# PORT OF TACOMA

## SITE FACILITIES FOR TACOMA TERMINALS INC.

### CONTAINER TERMINAL CONTRACT NO. 560

DRAWN RHT DATE 5-29-84	<b>PORT OF TACOMA</b> TACOMA TERMINALS, INC. COVER SHEET	SCALE NONE
CHECKED LTP DATE 5-30-84		DRAWING NO. EP-3880-23-G001
CHECKED P DATE 5-30-84		SHEET 1 OF 88
FIELD BOOK (S)		
APPROVED John J. Terpstra 5/31/84 DATE	PROJECT MANAGER Robert L. MacLeod 5/21/84 DATE

DRAWN: EHT DATE: 5-30-84 CHECKED: J.T.P. DATE: 8-30-84 CHECKED: P DATE: 5-30-84 CONT. NO.: 560	<b>PORT OF TACOMA</b> TACOMA TERMINALS, INC. PAVING & DRAINAGE PLAN
FIELD BOOK (S) APPROVED: <i>John T. ...</i> 5/31/84 DATE: 5/31/84	SCALE: AS NOTED DRAWING NO.: EP-3880-23-C 301 SHEET: 21 OF 88

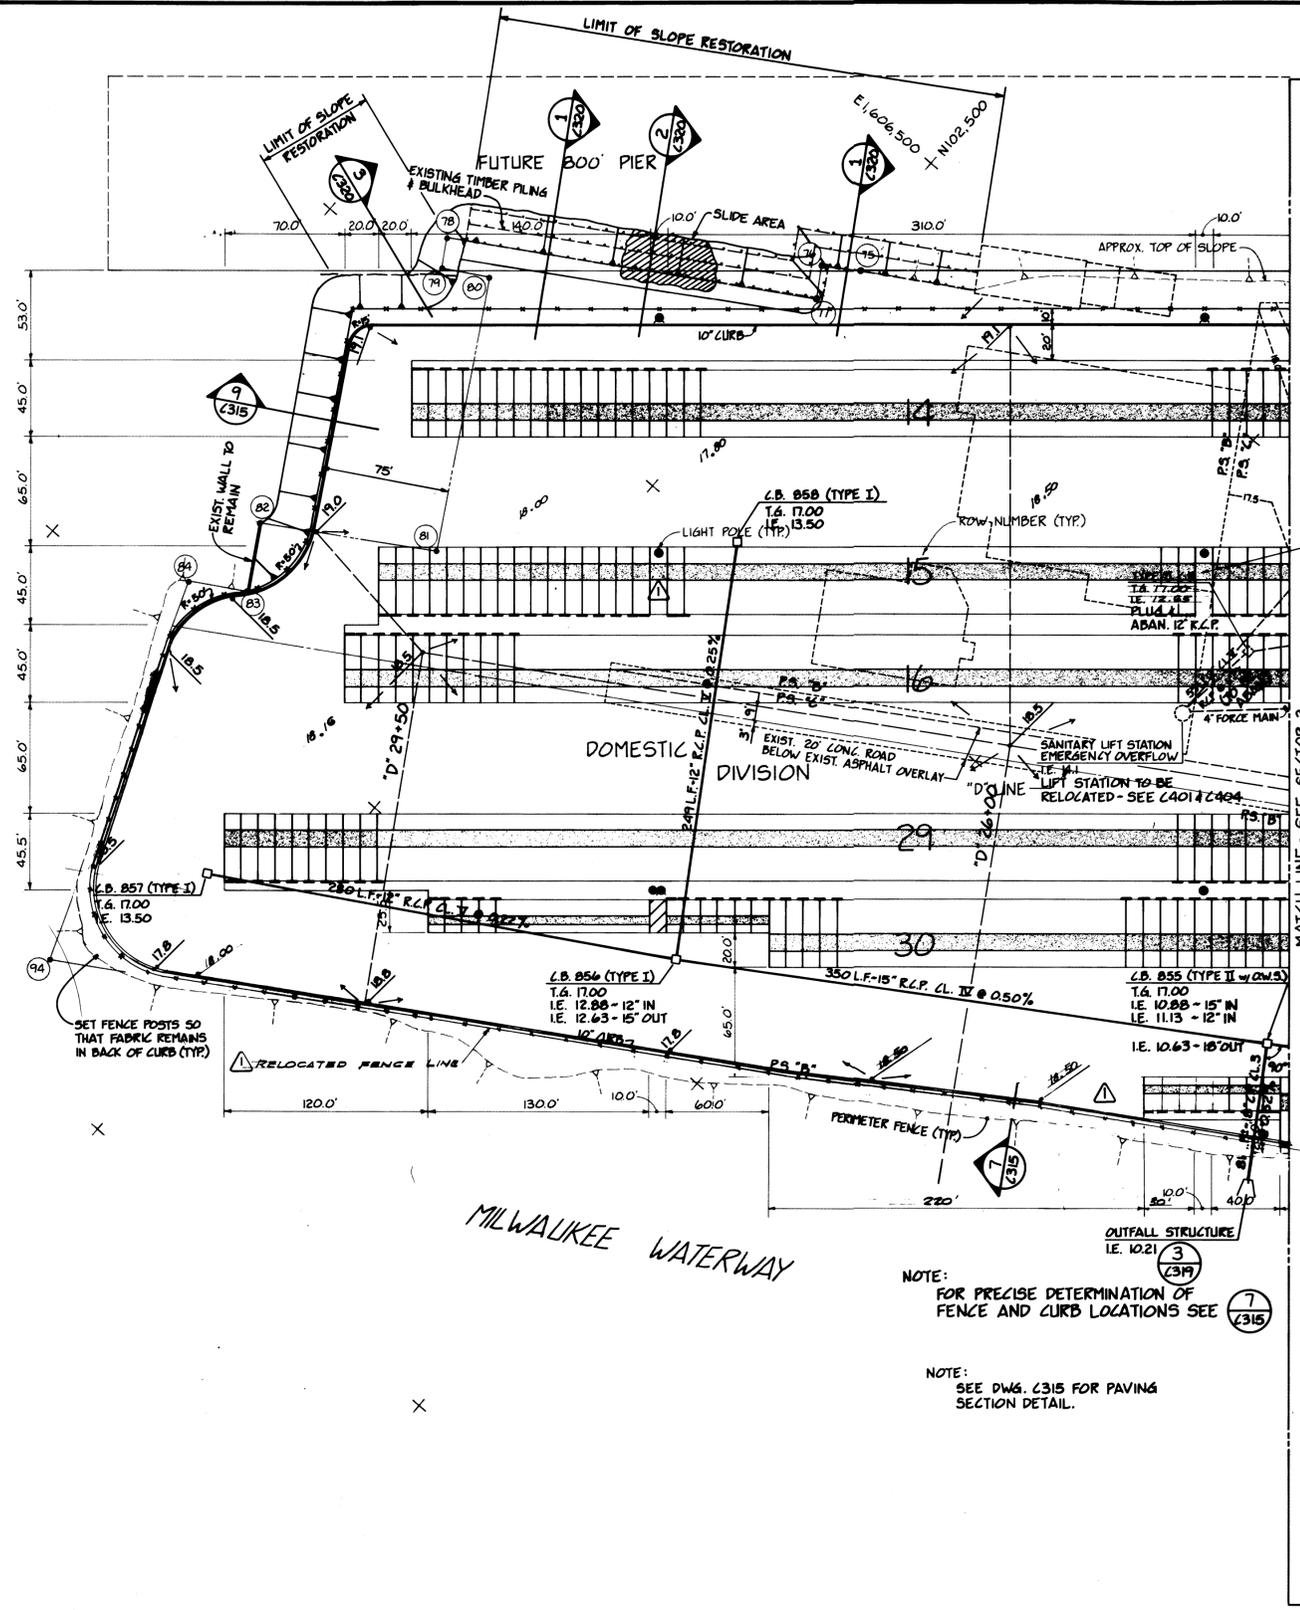
DELETED 10' WIDE GAP IN DOLLY STRIP PER ADDENDUM NO. 2
